MHTN
ARCHITECTS

Addendum No. 02

Project Name: **SJSD Albert R. Lyman Middle School**

Addendum No. 02 to the Construction Contract for the above-referenced project:

C3 NORTH RAMP B

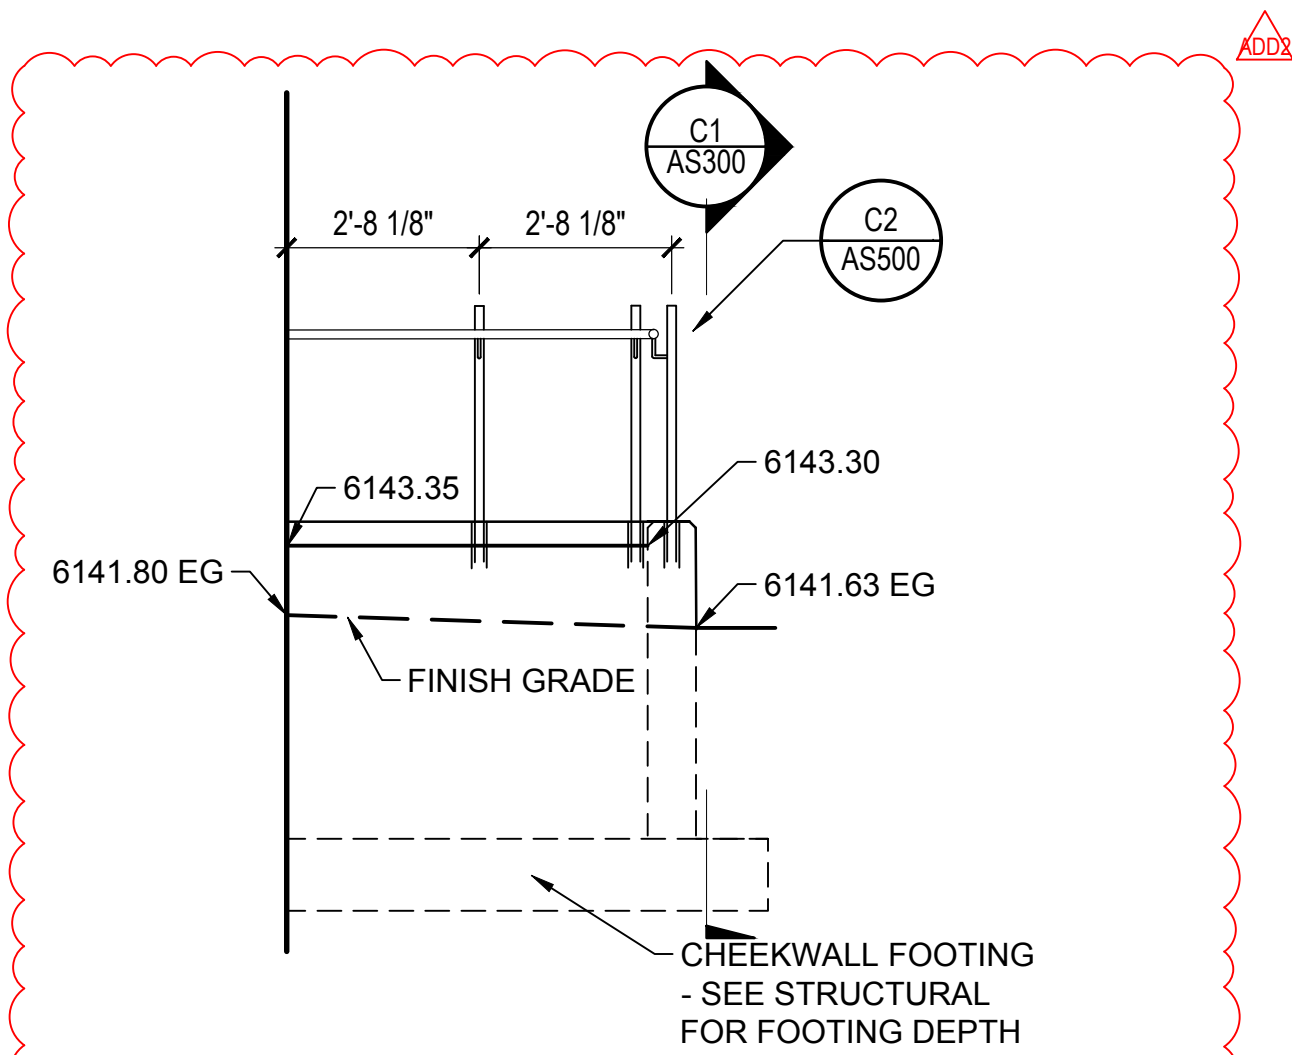
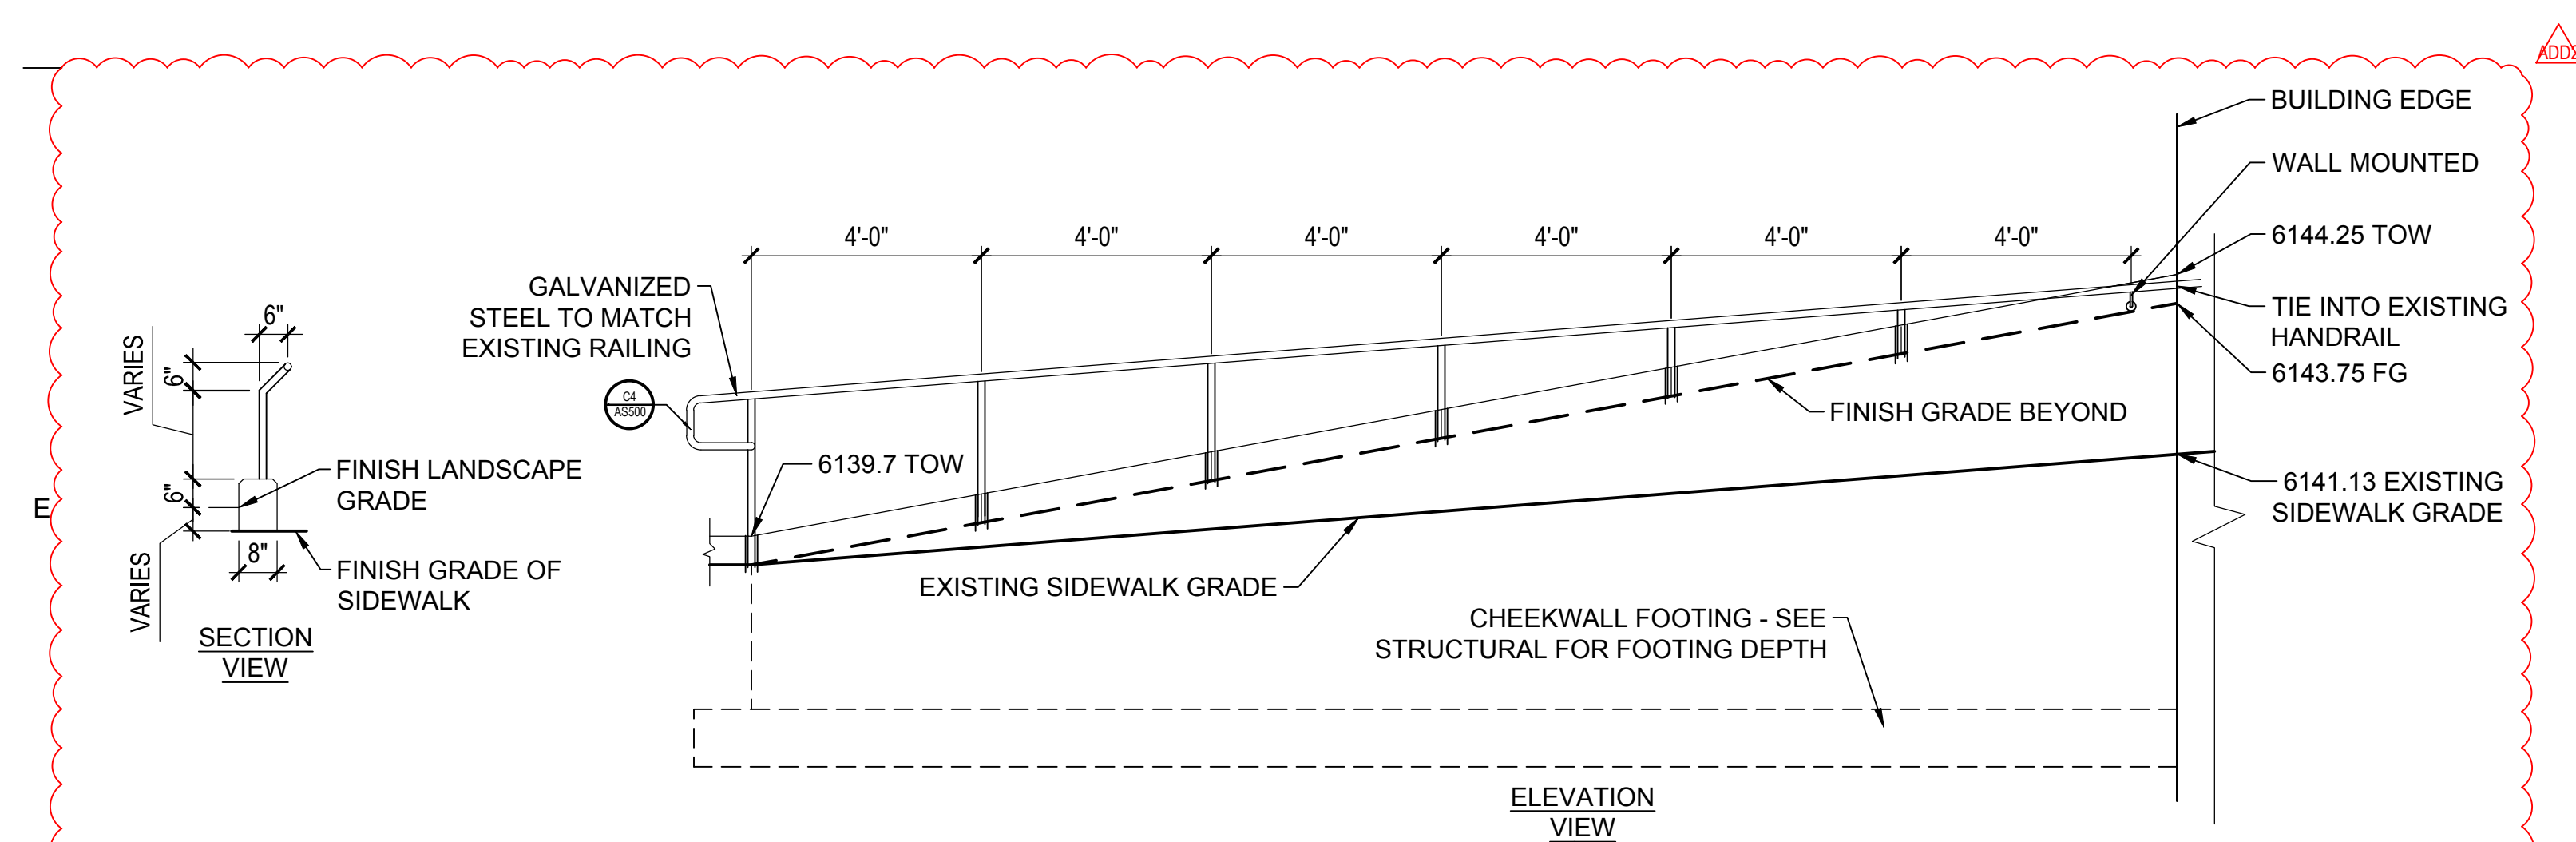
1. Added elevations and details to clarify cheekwall locations and construction.
